February 14, 2024

Re: Division Adequacy Review No. 1; Technical Revision 141 (TR-141) Grassy Valley Monitoring Well Installation – Phase 1, Permit No. M-1980-244

Attachment 1: Shallow Groundwater Investigation Workplan
Attachment 2: Collier Geophysical Transect Figures
Attachment 3: ECOSA Monitoring Well Access Road Map

Attachment 2: Collier Geophysical Transect Figures

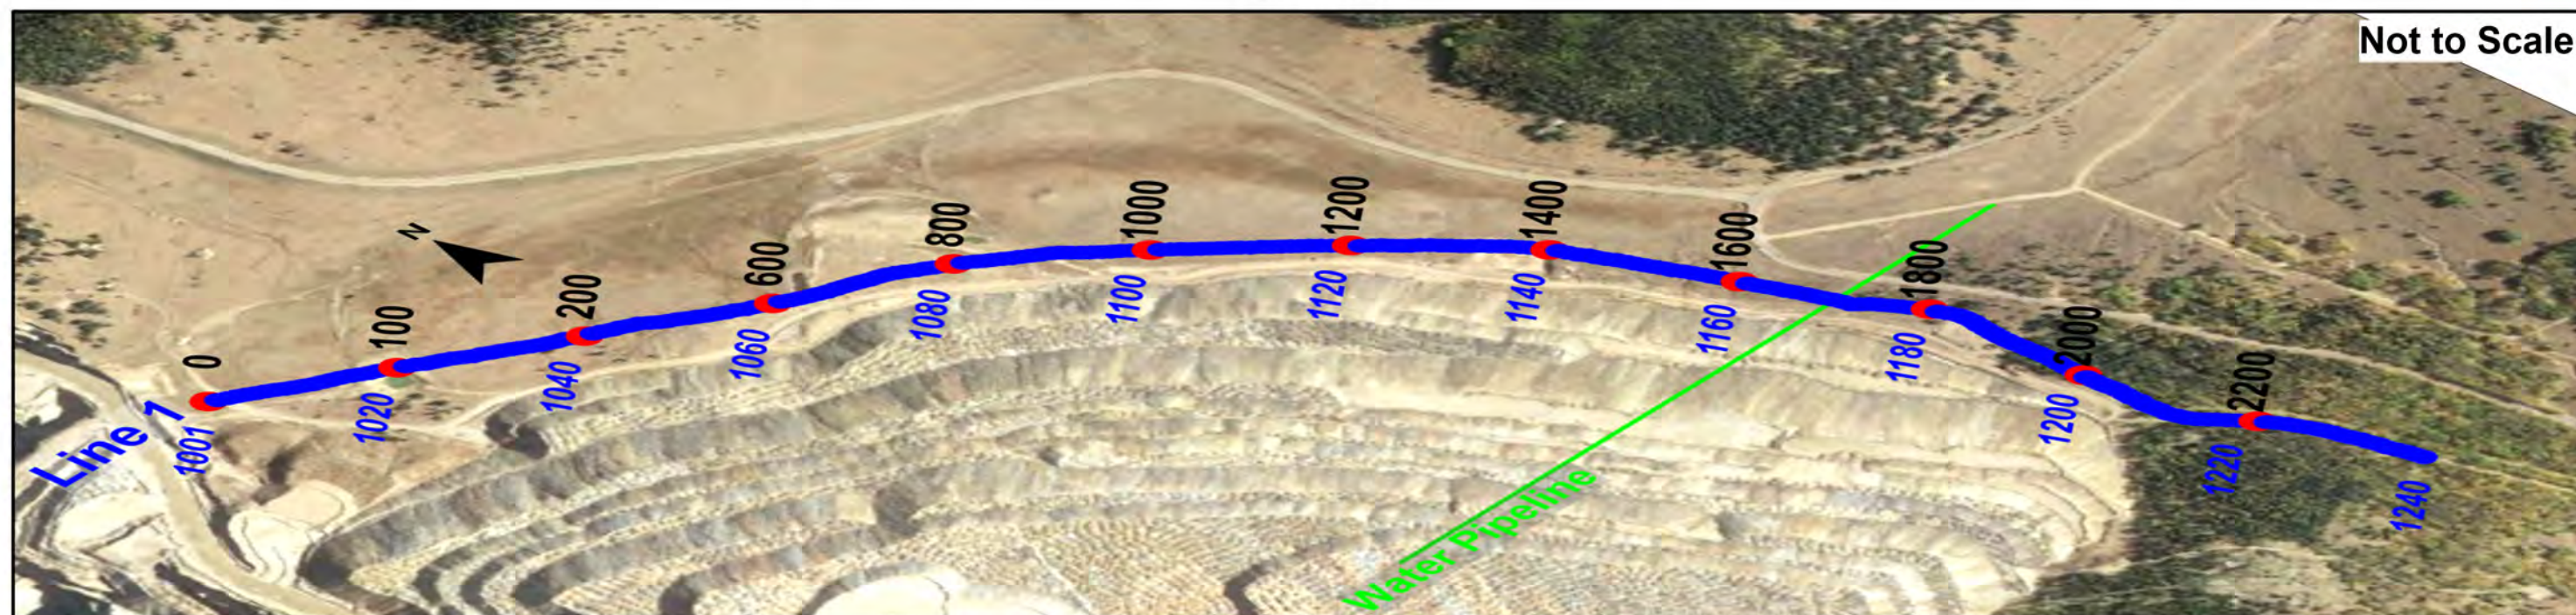
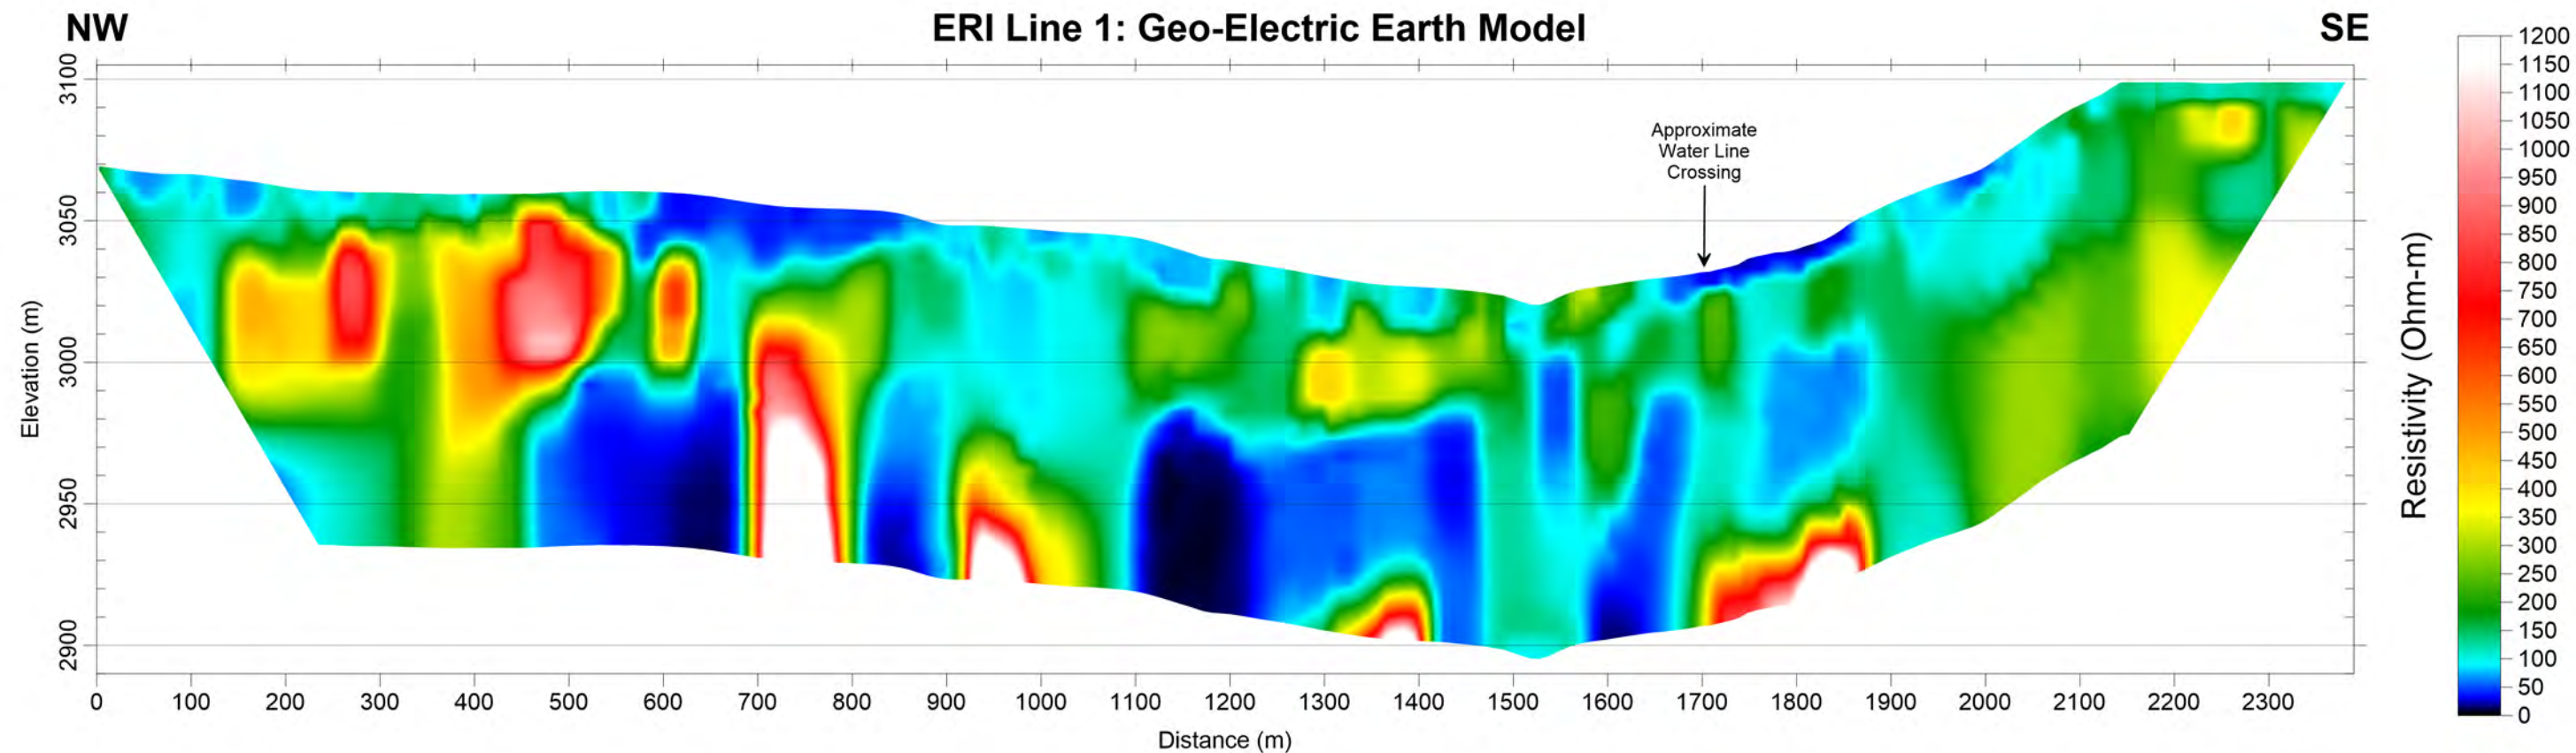
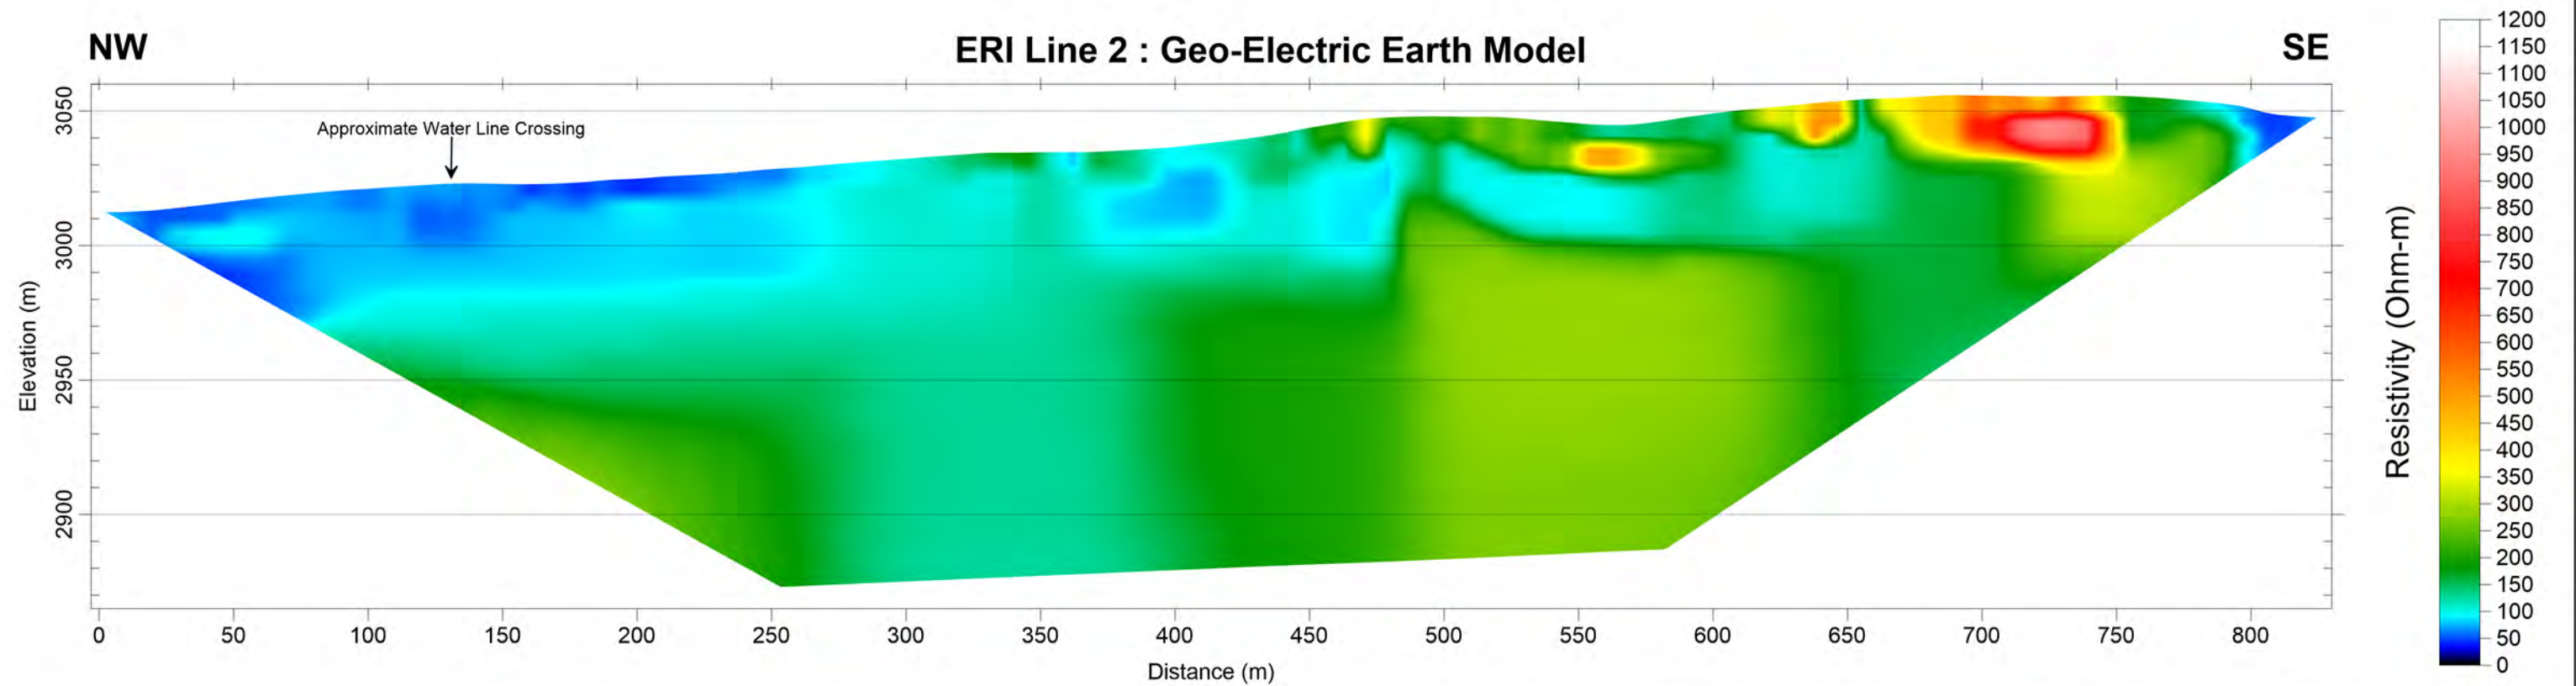
- 5. The Division was not aware the Operator performed a geophysical survey of Grassy Valley by Collier Geophysics (Collier). Provide a figure that shows all the geophysical transects that were performed by Collier in Grassy Valley.**

- 6. The Operator needs to provide a detailed discussion regarding interpretation of the results of the Electrical Resistivity Imaging (ERI) survey. Include in the discussion how potential seepage pathways relate to low and high resistivity zones identified by the ERI survey and why.**

Collier Geophysics was retained to conduct an ERI geophysical survey in Grassy Valley to address gaps in the previous survey. The previous geophysical work used an electromagnetic method that achieved only relatively shallow penetration into the subsurface which did not provide the necessary information to determine the potential subsurface flow paths. Collier Geophysical Survey figures showing electrical resistivity profiles for both transects are included in Attachment 2.

The Electrical Resistivity Imaging method is used to characterize subsurface lithology and/or materials in terms of electrical resistivity. Electrical resistivity (the reciprocal of conductivity) is a material property which is diagnostic of the type of geologic material present. Unsaturated soils have higher resistivity (lower conductivity) than saturated soils. Materials saturated with water containing high total dissolved solids have very low resistivity values (high conductivity) that could indicate potential seepage pathways from ECOSA. As described in the Work Plan and shown in Figure 1 of TR-141, the proposed monitoring well locations were selected based on the low resistivity areas (shown in blue on Figure 1) observed from the ERI Survey.
